**Marty Stuart's Congress of Country Music – Ellis
Theater Renovations**

MECHANICAL/PLUMBING BID PACKAGE

ADDENDUM NO. 4

TO: All Bidders on the Above Referenced Product
FROM: Dryden Architecture + Design
DATE: October 22, 2021
SUBJECT: **ADDENDUM NO. 4**

M-101

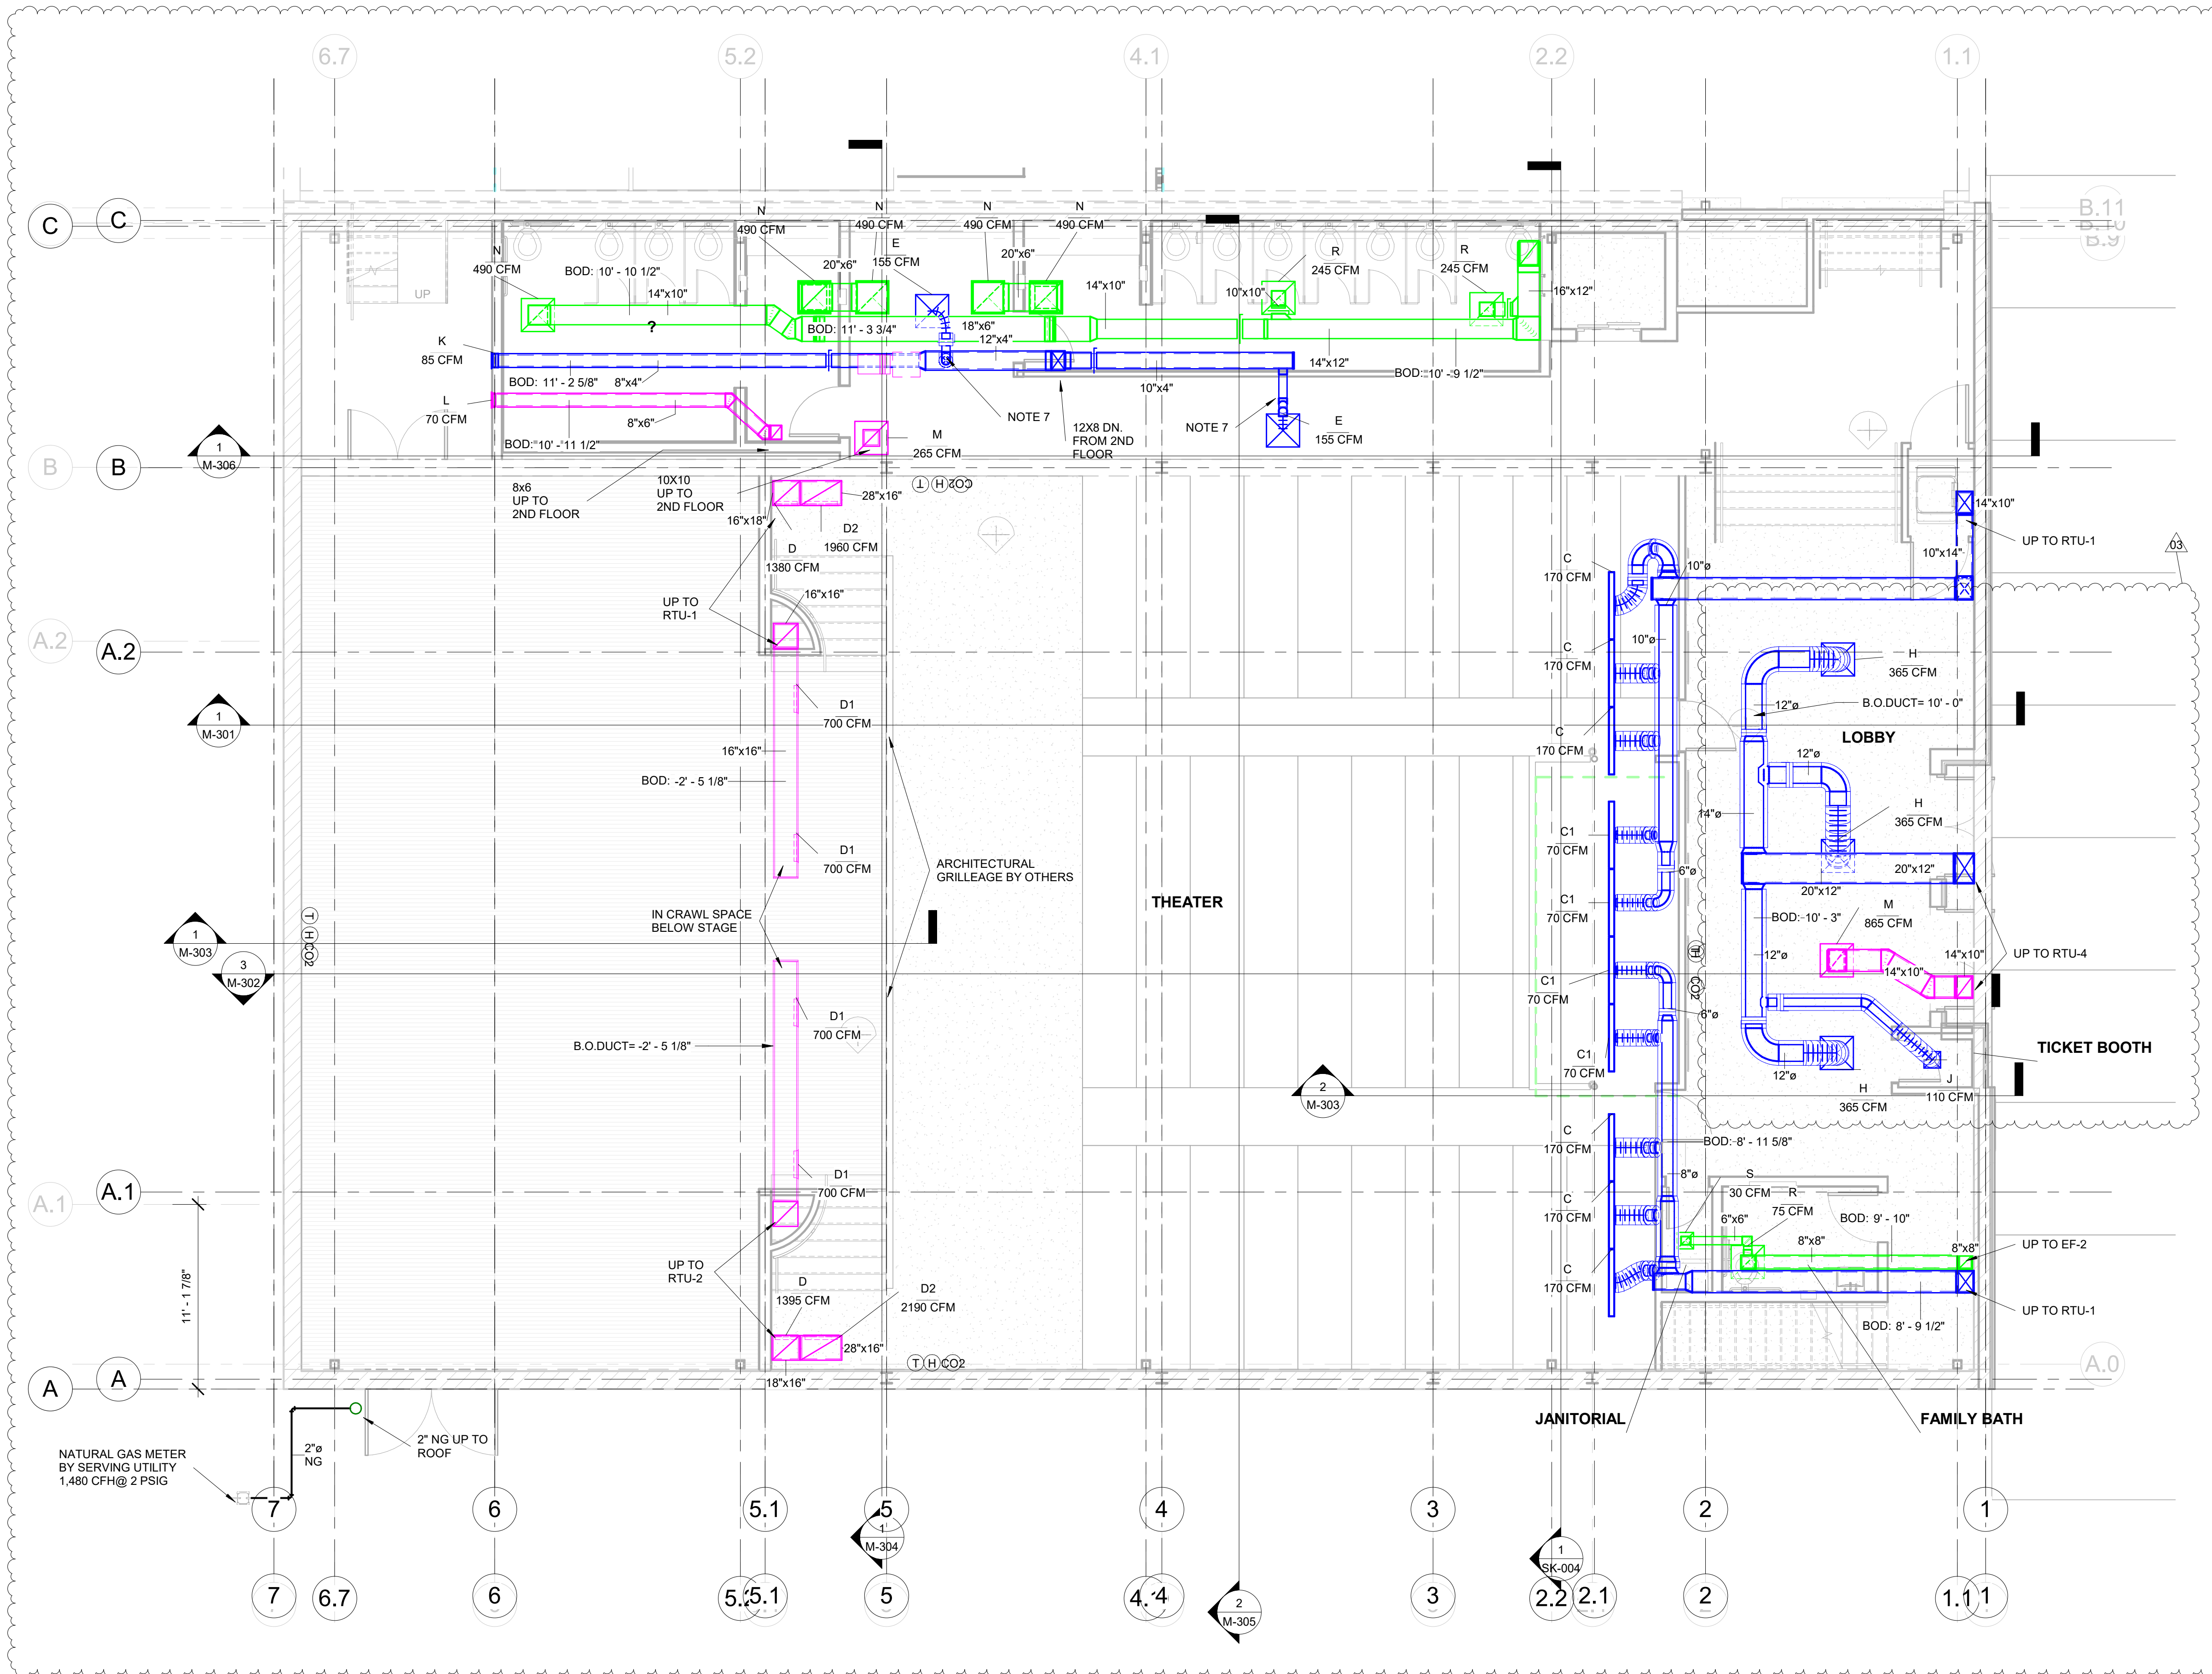
7. **CLARIFICATION:** Drawing M-601 Mechanical Schedules, Rooftop unit Schedule, Item 7 states "PROVIDE BACNET MSTP THERMOSTAT WITH IES CLOUD BASED CONTROLS OR EQUAL". A WIFI controllable thermostat will be sufficient.
8. **REPLACE:** Drawing M-101 First Floor HVAN Plan No.2 with M-101 No. 3 (attached)
9. **REPLACE:** Drawing M-102 PNC SECOND FLOOR HVAC PLAN Plan No.2 with M-101 No. 3 (attached)
10. **REPLACE:** Drawing M-303 ELEVATIONS No.2 with M-101 No. 3 (attached)
11. **REPLACE:** Drawing M-601 MECHANICAL SCHEDULES Plan No.2 with M-101 No. 3 (attached)
